Commercial Preliminary Development Plan (PDP)

Bank of America – 1801 NW Chipman Rd
Application #: PL2025307
City Council Hearing 2/24/2026

Project Details - Site Plan

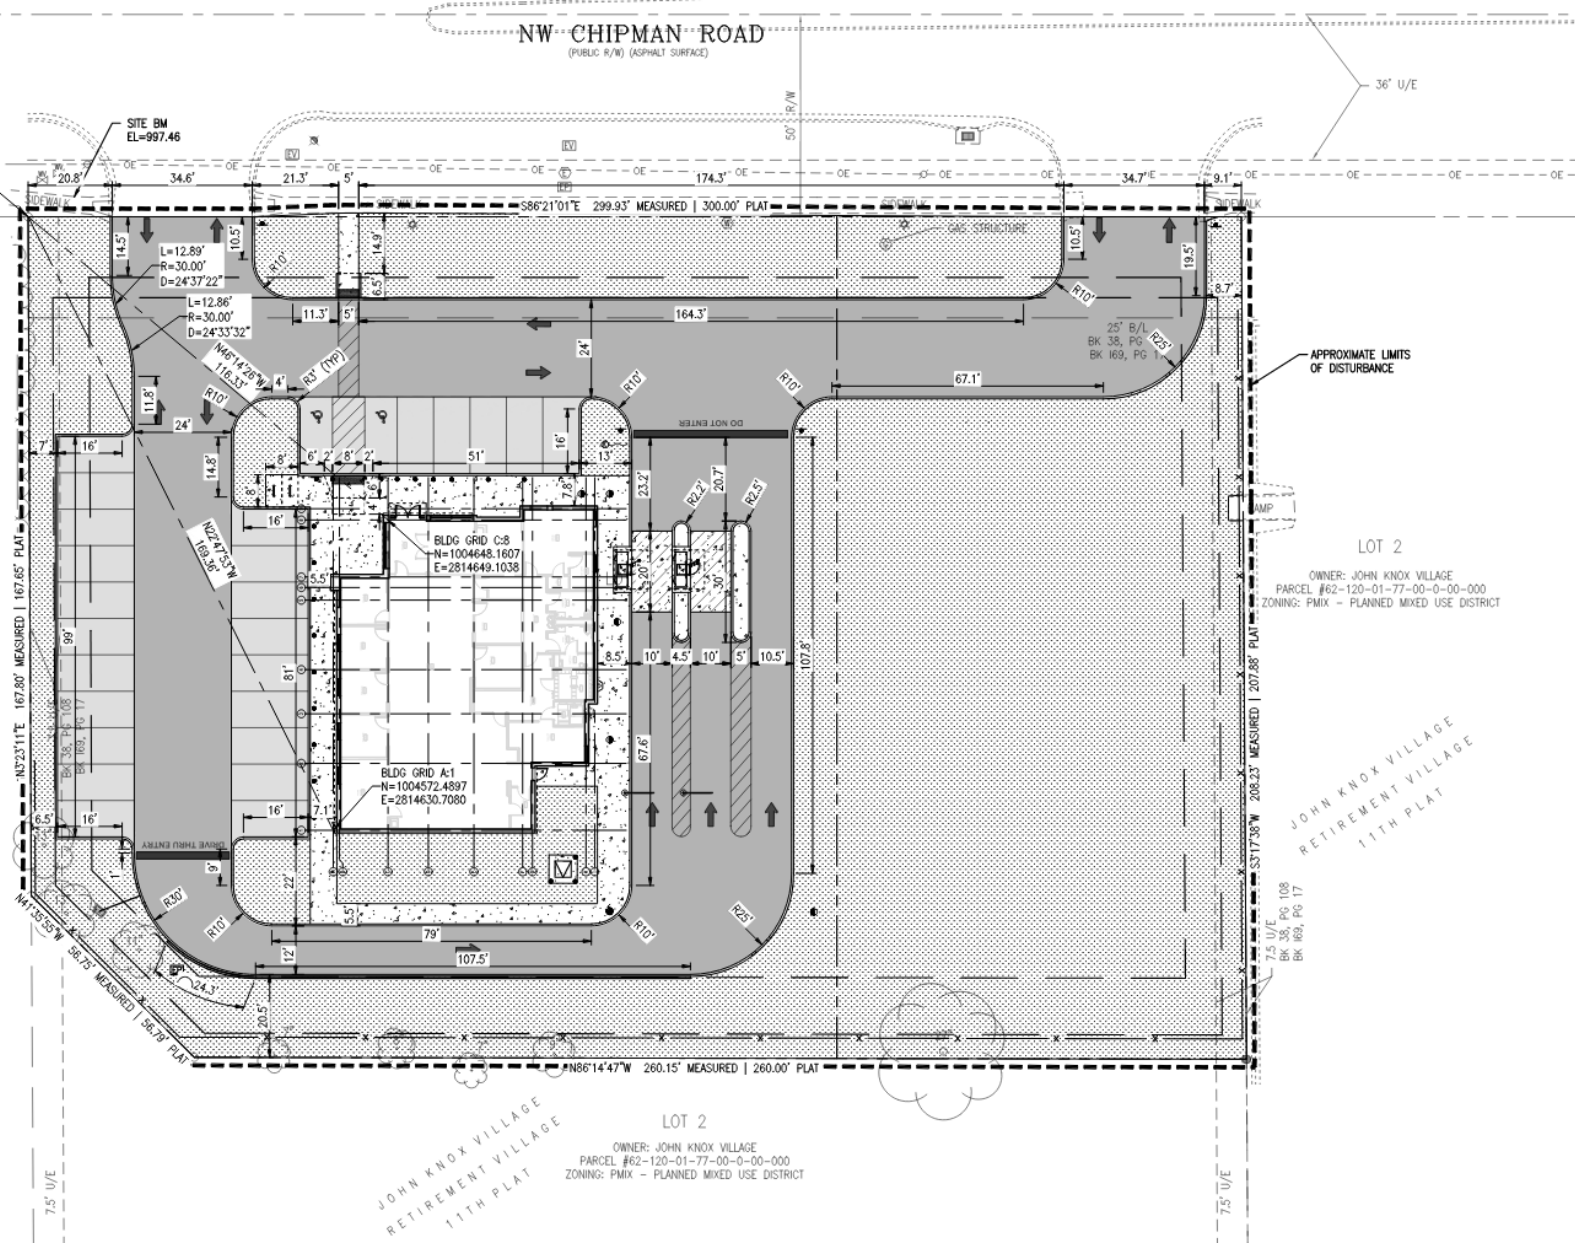
- Comment: PARKING DESIGN. A minimum 20' parking lot setback is required from any adjacent residential use. The western boundary of the proposed parking lot is set back 8'-6" from the abutting residential property. A modification to the minimum parking lot setback shall be required to be approved as part of the subject preliminary development plan process. Staff will support granting a modification to allow the parking lot setback as shown on the plans.

- Response: A modification to the parking lot setback on this side is requested (from 20' to 6' as shown in plans)
- Comment: PLATTING. Please note that the future subdivision of the subject property will require a replat of the site via the minor plat or final plat process. This process need not be undertaken until such time as the current property owner intends to convey a portion of the subject property to a separate party.
